Subject: MHI's Responses to US-APWR DCD RAI No. 621-4947 Revision 2

Response to Request for Additional Information No. 621-4947,
Revision 2

US-APWR Design Certification

RAI NO.: NO. 621-4947 REVISION 2
SRP SECTION: 19.01 – Determining the Technical Adequacy of Probabilistic Risk
Assessment Results for Risk-Informed
APPLICATION SECTION: 19
DATE OF RAI ISSUE: 08/30/2010

Figure 1 Loss of RHRs caused by Seismic Event Tree
(From DCD Revision 2 Figure 19.1-18)

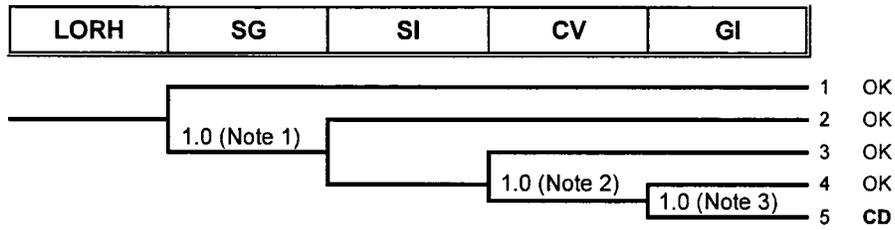
As discussed at the NRC staff audit of the shutdown PRA on July 8, 2010, the staff requests MHI to update the shutdown PRA and the DCD to provide a discussion on how the min-max seismic margins approach was applied to shutdown. The staff is requesting the applicant to update the shutdown PRA to include the seismic cutsets and the sequence HCLPF capacities using the min-max method. The staff also requests MHI to update the shutdown PRA to include the dominant mixed cutsets containing seismic failures and random failures.

Core damage sequences of LPSD are simple. For example, as shown in Figure 1 (DCD Revision 2 Figure 19.1-18 "Loss of RHRS caused by Other Failures Event Tree"), if any one of the mitigating systems is available, the event will not result in core damage.

Key random failures/human errors during LPSD are reviewed. For POS 8-1 and the initiating event LORH, only the SI system is expected to be functional after a seismic event, as noted on Figure 1.
